**NSLPP MEETING HELD ON 02/02/22**  
**SECTION 4.55 APPLICATION REPORT**

**ADDRESS/WARD:** 30-34 Grosvenor Street, Neutral Bay

**APPLICATION No:** DA 237/20/2

**PROPOSAL:** To modify an approved four (4) storey residential flat building including changes to floor levels, internal layout changes within the basement levels, an additional basement level and an addition to the lift overrun.

**Figures 1 – 4: Proposed Modifications**

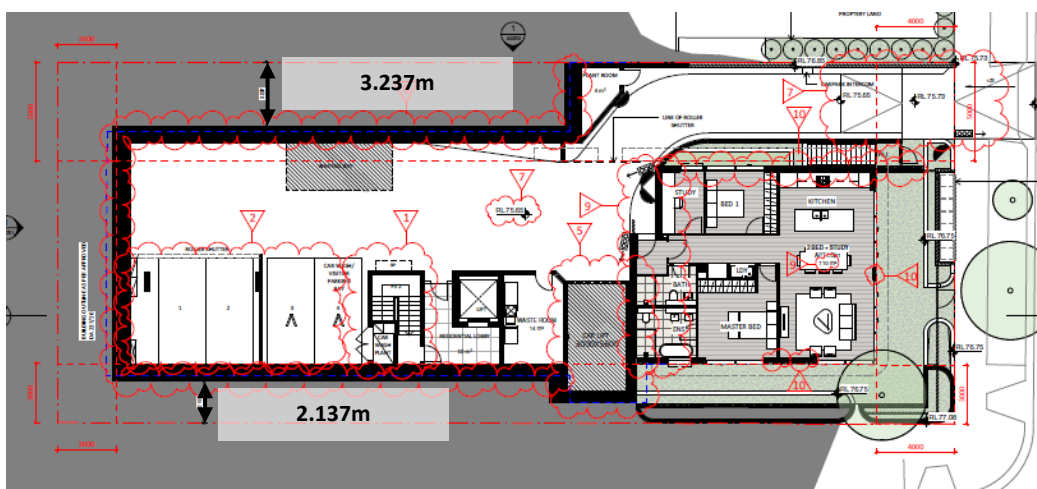
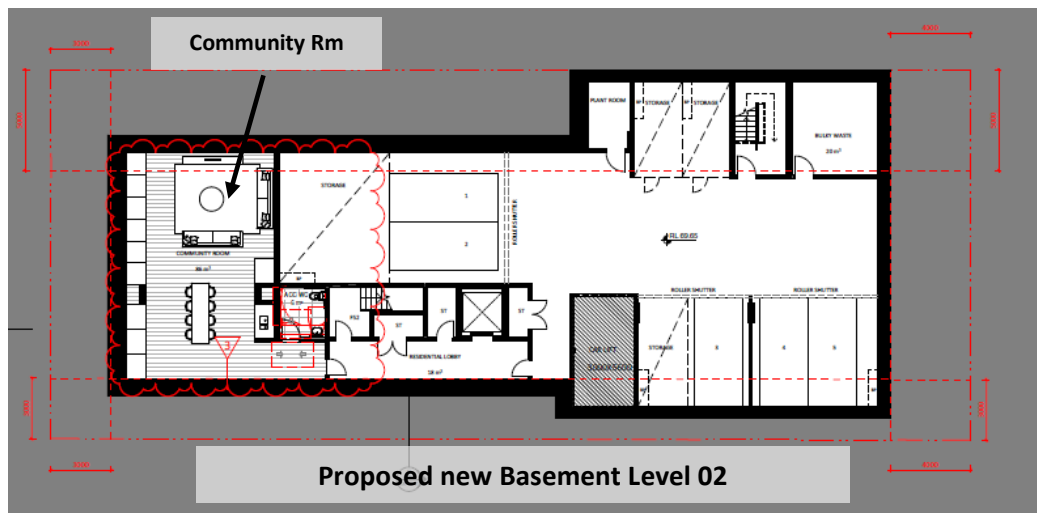
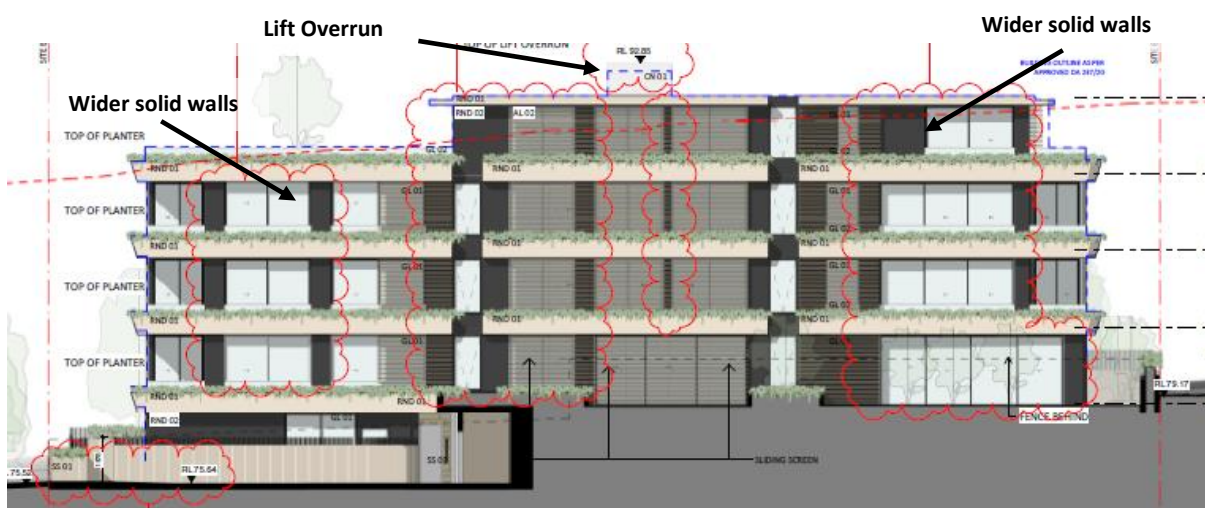
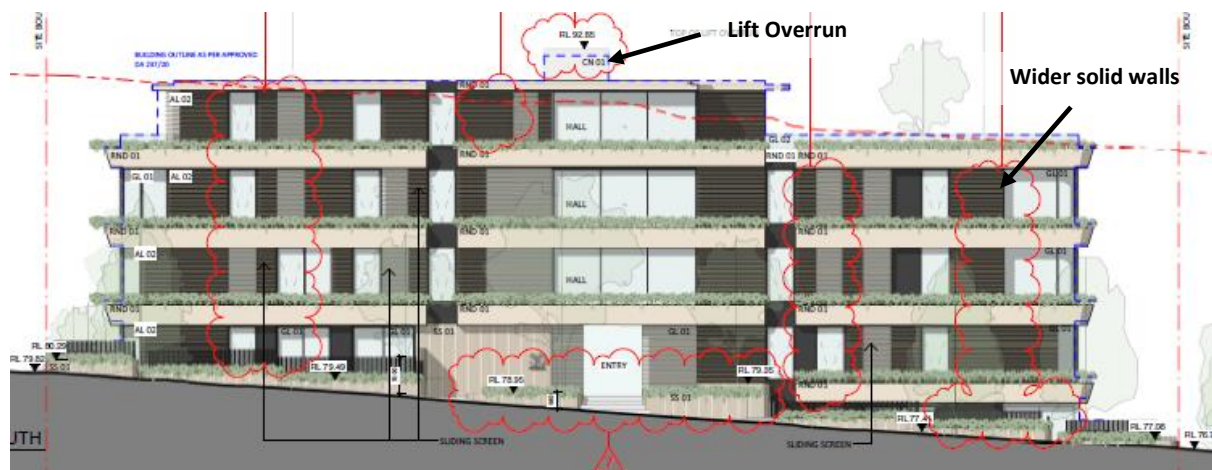
- (a) The addition of a new basement level 02 at RL69.65 matching the footprint of the basement level 01 above to provide five (5) parking spaces, storage areas, a plant room, a bulky waste room and a community room;

- (b) Modifications to the property boundary setbacks for the basement level 01 to provide setback of 3.237m to the northern property boundary and 2.137m to the southern (Grosvenor Street) boundary;

- (c) Modifications to the internal layout of parking areas on basement level 01 and the lower ground level to provide ten (10) parking spaces (including two (2) accessible parking spaces and two (2) visitors spaces), two (2) motorcycle parking spaces, bicycle parking, a plant room, a sprinkler & hydrant pump room and a car lift connecting all parking levels. Installation of roller shutters in front of certain parking spaces and storage areas on basement Levels 01 and 02;

- (d) Modifications to the building facades including the widening of some external walls and the addition of solid upstands to planters along the perimeter of the building;

- (e) An increase in the height of the lift overrun from RL92.55 to RL92.85;
- (f) Modifications to the floor levels:

**Figure 9: Proposed Development and the LEP Maximum Building Height**

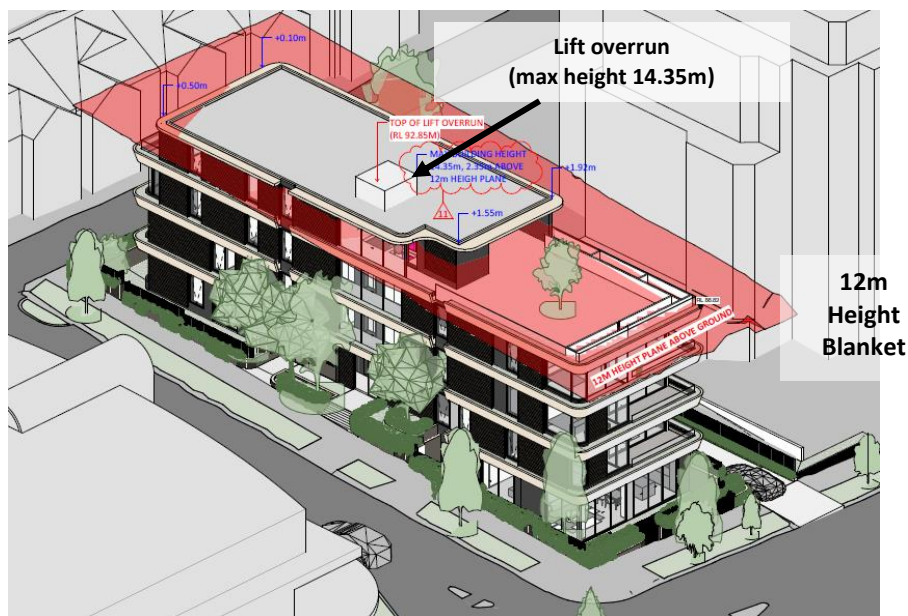
The maximum building height breach would be 2.35m for the top north-eastern corner of the lift overrun. The non-complying building elements are shown in red in **Figure 9** below.

The modified building elements in breach of the LEP building height limit would primarily be the lift overrun because the levels and the design of the roof above the apartment and the communal room on Level 03 are unchanged.

It is considered that the proposed modifications to the lift overrun would have no material impacts on significant views as seen from the public domain and surrounding properties as well as additional shadowing onto the adjoining properties because the location and the scale of the modified structure located away from the edge of the approved building. Therefore, the lift overrun would not be highly visible from the public domain and the adjoining properties and any additional shadows would fall on the roof of the subject apartment building.
